Product Bulletin

5-Way Manifold New Safety Warnings

Location of the new WARNING label

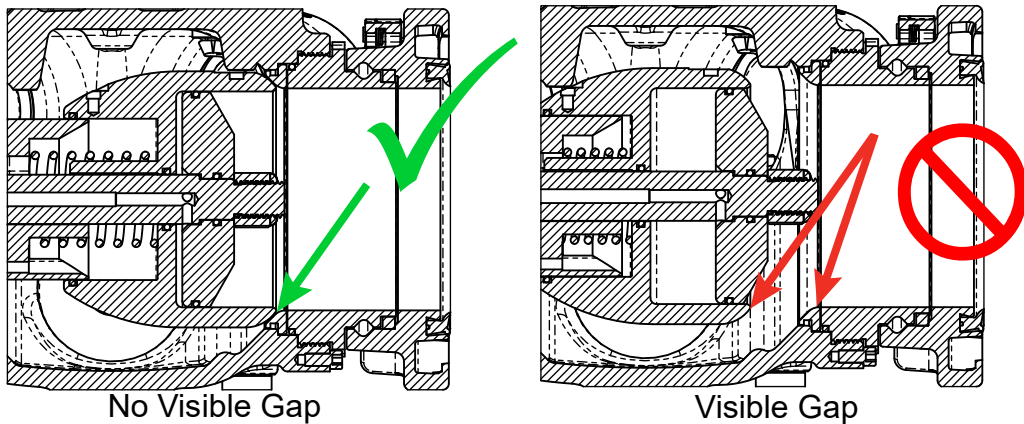
The TFT Service and Support team recently observed a 5-Way Manifold returned from a customer in which the LDH shutoff valve was not fully closed following use. Please heed the following warnings and affix the enclosed safety label to the location shown below. Also, read the revised literature **LIA-535 5-Way Manifold Instruction for Installation, Operation and Maintenance (Revision 06)**, which is available at tft.com/serial-number.

Initiation of water flow to this appliance while any valve is open can cause the appliance to become unstable or out of control, resulting in serious injury or death. To avoid an out of control appliance, visually verify all valves are in the closed position by looking into all outlets before connecting hose and flowing water.

Do not use the 5-Way manifold if a gap is visible between the sliding plug and valve seat as viewed from the LDH outlet. A gap indicates a malfunction that will require repair or replacement.
